| CHECKED <i>[Signature]</i> | APPROVED <i>[Signature]</i> | DRAWING NO. DSI 9150 | REV. A SHEET 1 OF 1 |
| DATE 99.04.01 | | TITLE ADD 206 SADDLE SPACERS | SCALE NTS |

DART SERVICE INSTRUCTION

AMEND INSTALLATION INSTRUCTIONS: D206-642 REV. F

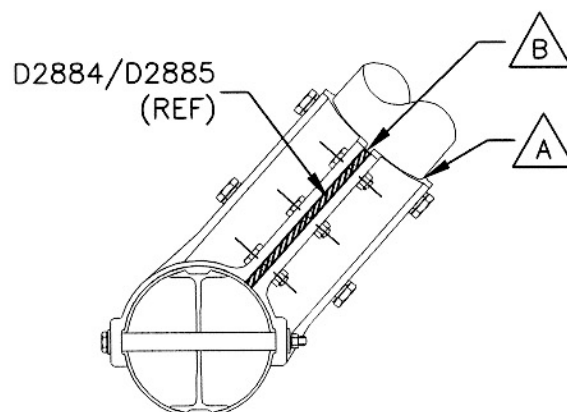
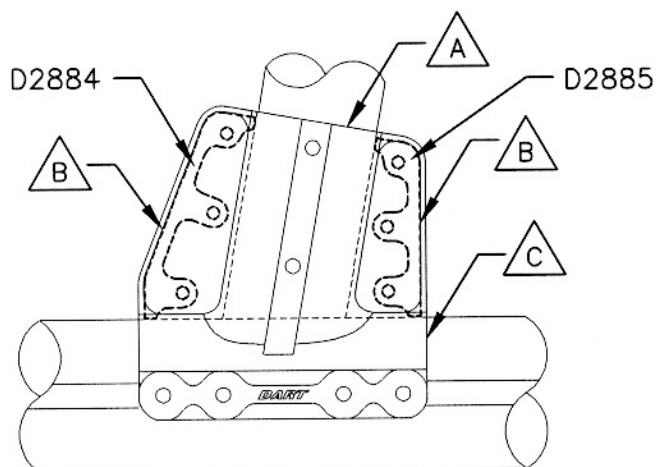
THIS MODIFICATION REQUIRES: (2) D2884 SPACERS
(2) D2885 SPACERS

INSTALL D2884/D2885 SPACERS ON D206-642-111/112/211/212/213/214/311/312/411/412 SKIDTUBE KITS AS OUTLINED BELOW. FOR SKIDTUBES ALREADY IN SERVICE, THIS SERVICE INSTRUCTION SHOULD BE PERFORMED AT THE NEXT INSPECTION INTERVAL.

- 1) INSTALL (1) D2884 AND (1) D2885 SADDLE SPACERS (1 ON EACH SIDE OF CROSSTUBE AS SHOWN BELOW) BETWEEN FWD SADDLE PARTS.
INSTALL (1) D2884 AND (1) D2885 SADDLE SPACERS (1 ON EACH SIDE OF CROSSTUBE AS SHOWN BELOW) BETWEEN AFT SADDLE PARTS.

- 2) TORQUE SADDLE FASTENERS PER DART INSTALLATION INSTRUCTIONS.
IT IS ACCEPTABLE FOR THE FLANGES TO BOTTOM OUT ON THE SPACERS.
- 3) APPLY A CONTINUOUS BEAD OF SEALANT IN ACCORDANCE WITH THE AIRCRAFT MAINTENANCE MANUAL IN THE FOLLOWING LOCATIONS:

- A** ALONG SADDLE/CROSSTUBE INTERFACE
B BETWEEN THE SADDLE FLANGES
C ALONG SADDLE/SKIDTUBE INTERFACE
